October 23, 2008

RE: HOLMES COUNTY AIRPORT AUTHORITY
GENERAL STORMWATER PERMIT
3GR01169*DG
HOLMES COUNTY

Jet Fuel Island

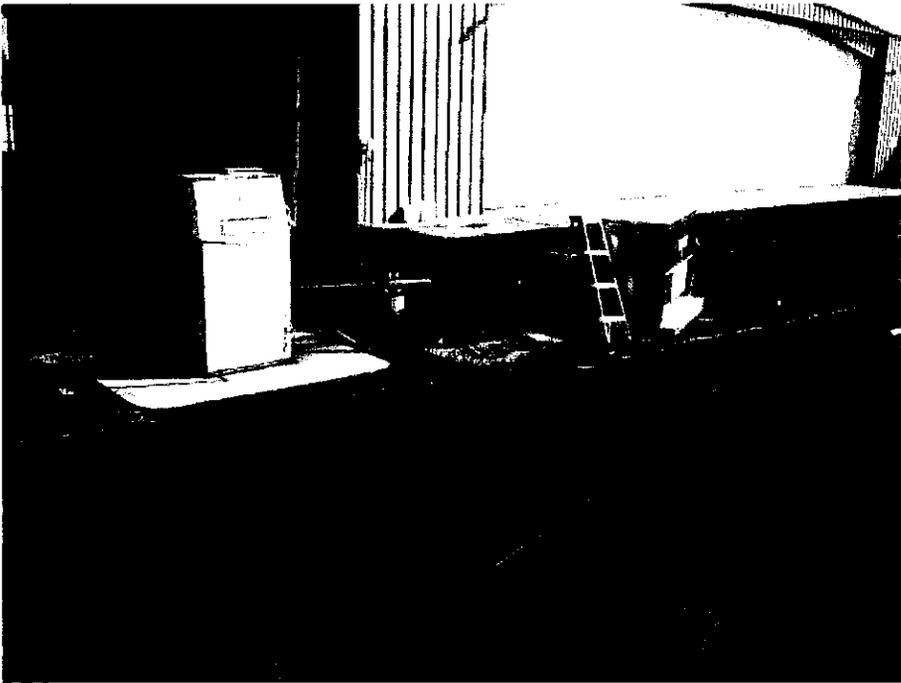
- This is a very small low volume airport that does not operate in icing conditions. No deicing materials are used on the runways or the planes.
- There is one Jet fuel island. No containment or bin containing spill containment/cleanup materials was present. A picture was taken and is attached below.
- No maintenance is done in the individual hangers.
- All maintenance is done in the building located next to the office. In this building there exists one trench drain. A picture was taken and is attached below. It was not obvious to where the trench drain connected. Mr. Miller did not know where it discharged.
- Mr. Miller was unfamiliar with the stormwater program and was not able to show me your Stormwater Pollution Prevention Plan (SWPPP).

- 1) A containment/cleanup bin should be located near the jet fuel island and be easily accessible should a spill occur. It should contain absorbent materials to be used in case of spillage of jet fuel.
- 2) Identify where the inside trench drain discharges.
- 3) Provide a copy of the SWPPP.
